Addendum to August 11, 2016 Application

315 S. Main Street
Ann Arbor, Michigan

**Ann Arbor Historic Distric Commission**
City of Ann Arbor
Planning & Development Services

***Summary of Proposed Changes Since the August 11, 2016 HDC Public Hearing:***

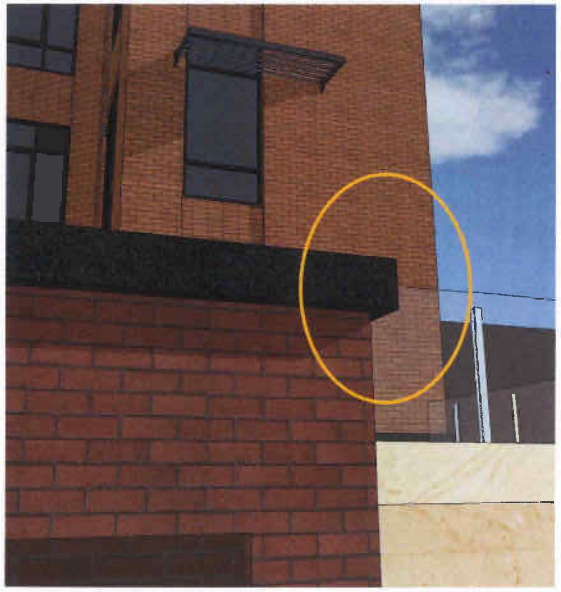
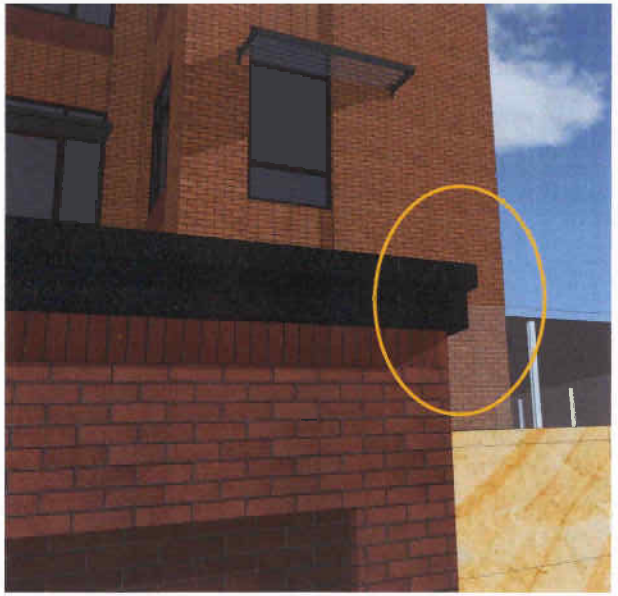
**1. Cornice Profile at Level 3:**
It was suggested that the cornice at Level 3 be re-designed to be visually stronger.

***August 11, 2016***
The detail shown below included a simple 6" black granite coping at the top of level three, center and north bays.

***September 8, 2016***
The proposed revised detail is an approximate 16" stepped granit coping with a full soldier course of face brick below.

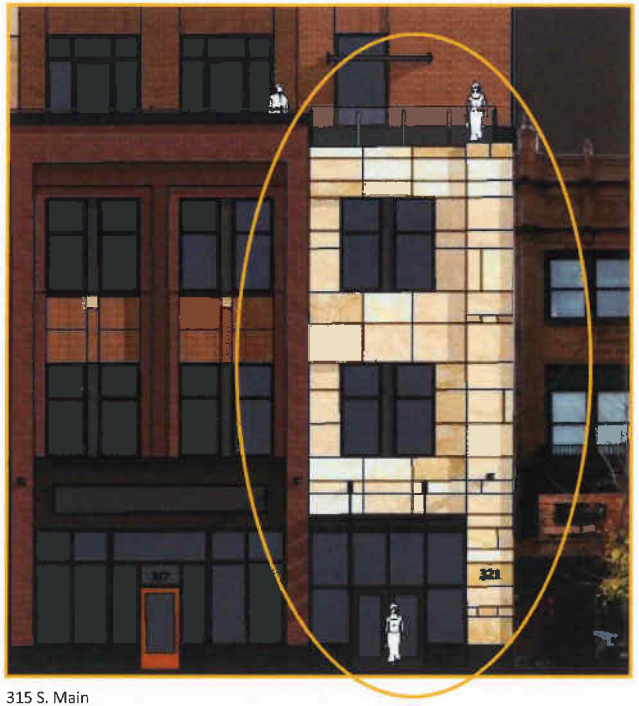
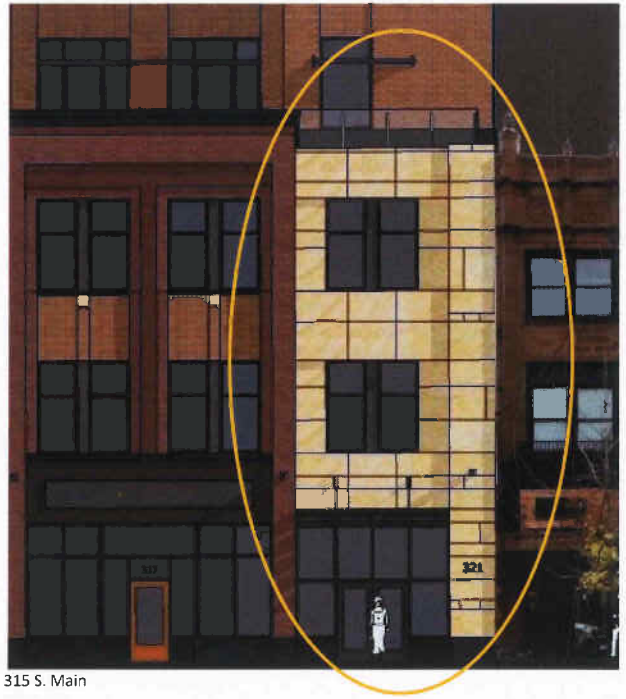
**2. Coloration of Mankato Stone:**
It was suggested that the Mankato stone be more uniform in color from stone to stone.

The proposed Mankato stone is quarried in Minnesota by Kasota Valley Limestone. In conversations with the supplier since the August 11 HDC meeting, we have been informed that a tighter range in coloration is possible.

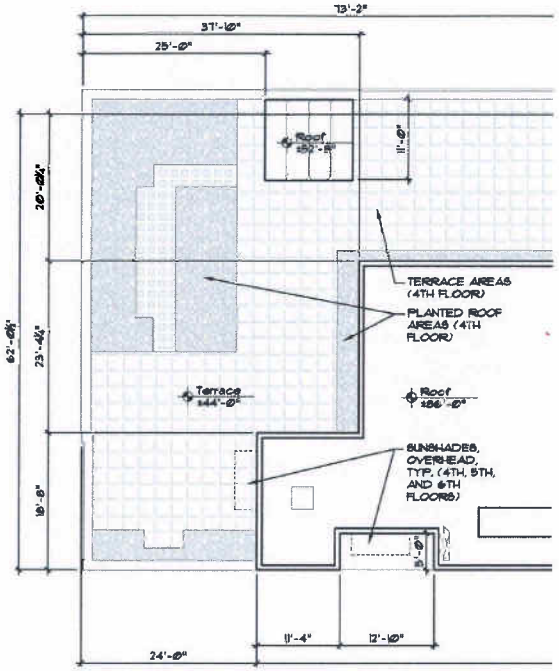
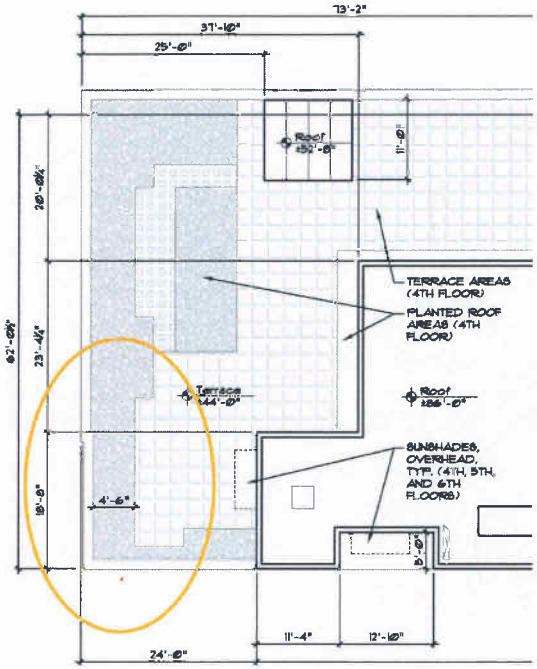
**4. Setback of Terrace Level Activity:**
It was suggested that active use of a roof-top terrace might be undesirable and the design team was asked to expand the landscaped area of the 4th floor terrace in front of the railing at the west edge of the south bay.

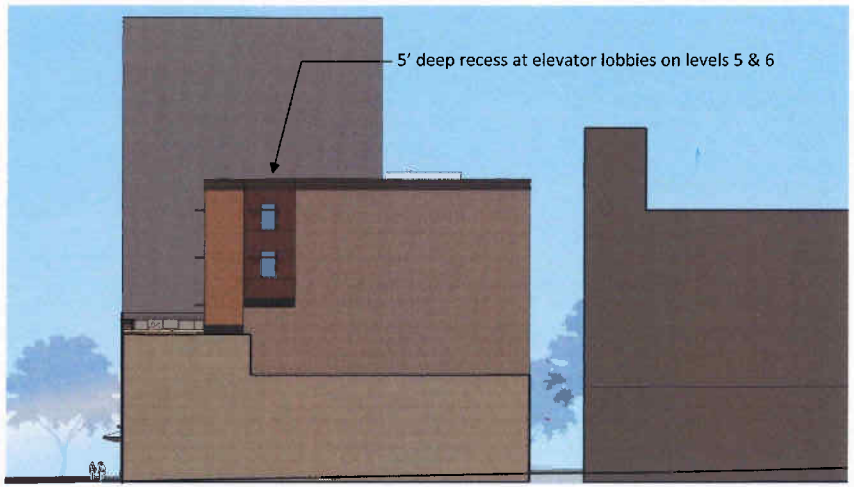
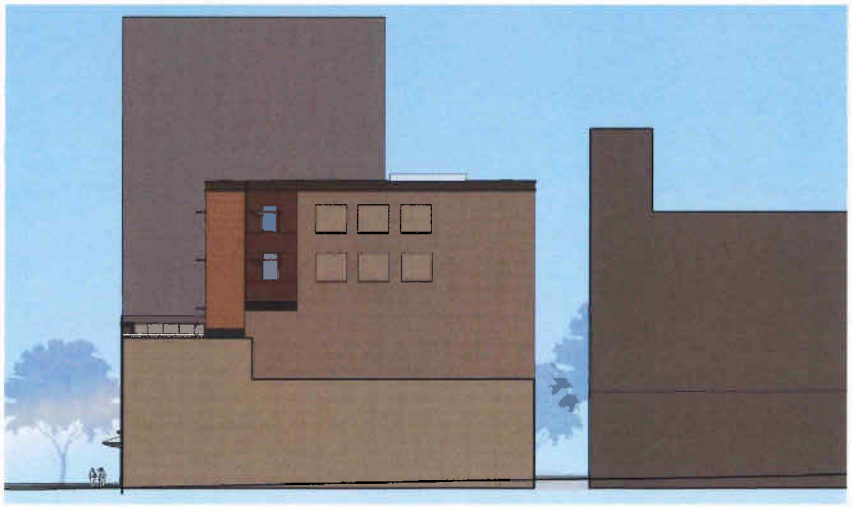
Commissioners generally favored the treatment of the west portion of the upper three south elevation floors, as shown below, due to the addition of a 5' deep recess at the elevator lobbies, offering visual relief to the party wall (this was an earlier suggestion by the HDC). It was suggested that a similar treatment be added to the east portion of the south wall.

Due to earlier advice from the HDC, we were able to create a 5' deep alcove with glazing is the elevator lobby on the 5th and 6th floors.

Knowing that current zoning in Ann Arbor allows for taller buildings outside the HDC District, to the south of the project site, and also knowing that south light can be severe and difficult to control in office settings, the design team placed all of the generally unoccupied building elements - including two enclosed egress stairs, an elevator, toilet rooms, and mechanical shafts - in the south bay of the building.

As discussed on August 11, openings in party walls (such as the south wall of 315 S. Main) are not allowed unless protected. However, on walls that are set 5' from party walls, up to 25% of the wall surface may be glazed.

Glazing and the setbacks that allow for glazing, were reserved for the north, west, and east exposures that provide the most beneficial daylighting for office use.

Opportunities for additional minimal 5' deep vo ume changes on the south elevat'on that respond to floor plan opportunities were sought, but none materialized.

The lower sketch to the left represents the proposed (revised) south elevation. We have included two rows of three approximatly 8' high X 11' wide recessed panels that align in height with the windows to the west. The surface of the panels are proposed to be placed 2" to 4" inside the main wall surface.

The recessed panels will be burnished or ground face block. The field of the wall will be split face block. The intent is to emphasize the horizontality with alignment of horizontal shadow lines.
